Re: Response to Audit Report for T-Mobile's Orange County Facilities

Response of T-Mobile West LLC dba T-Mobile to the Electric Safety and Reliability Branch's Audit Report dated February 12, 2026

Site ID: LA03015F

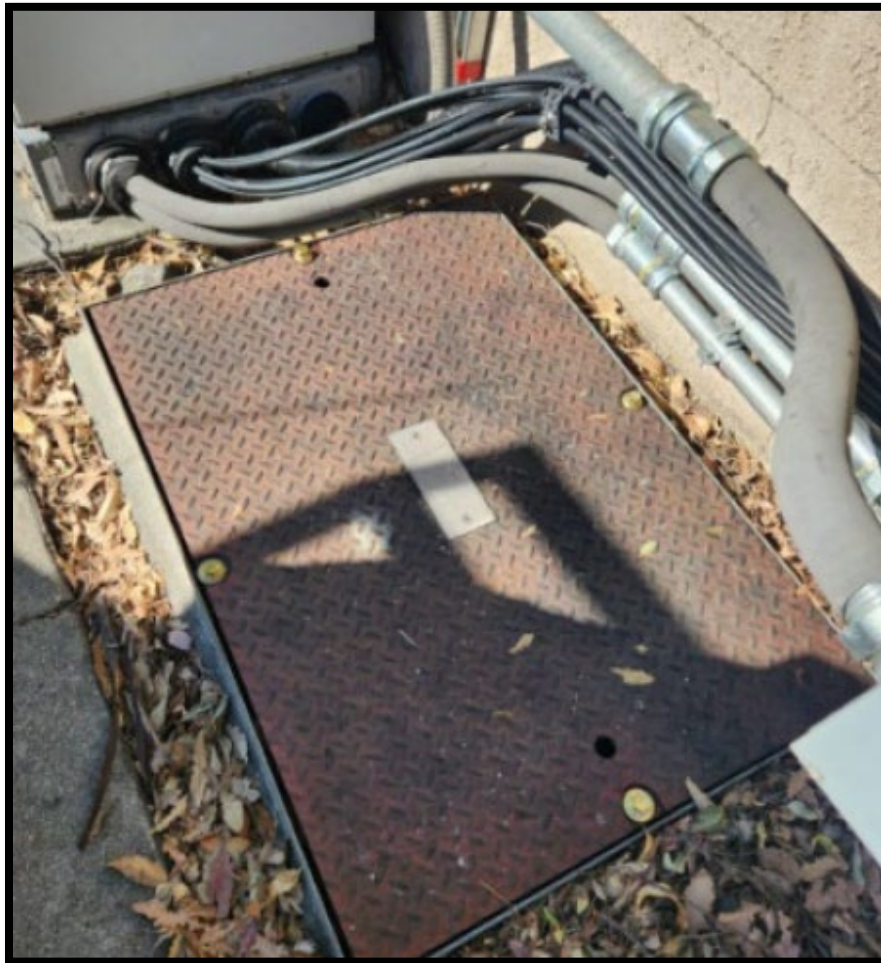
Staff Findings: The cover of the handhole at the location was not securely closed, allowing unauthorized access to the structures.

T-Mobile further notes that the handhole covers identified have now all been secured. See Attachment C (photos of the secured handhole cover for each site identified above).

Site ID: LA33451B

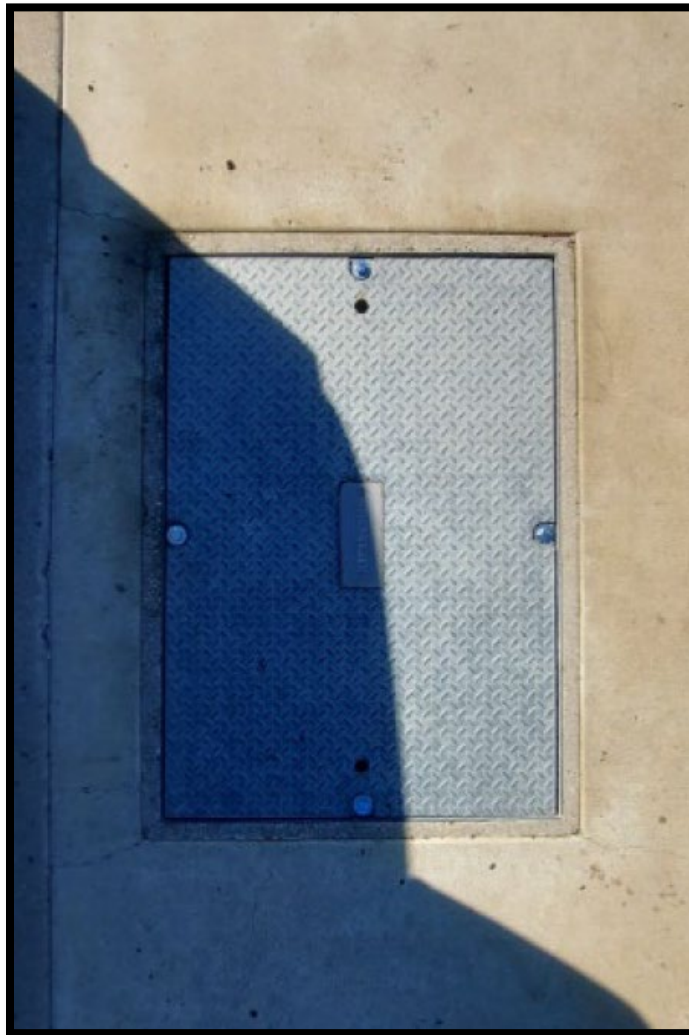
Staff Findings: The cover of the handhole at the location was not securely closed, allowing unauthorized access to the structures.
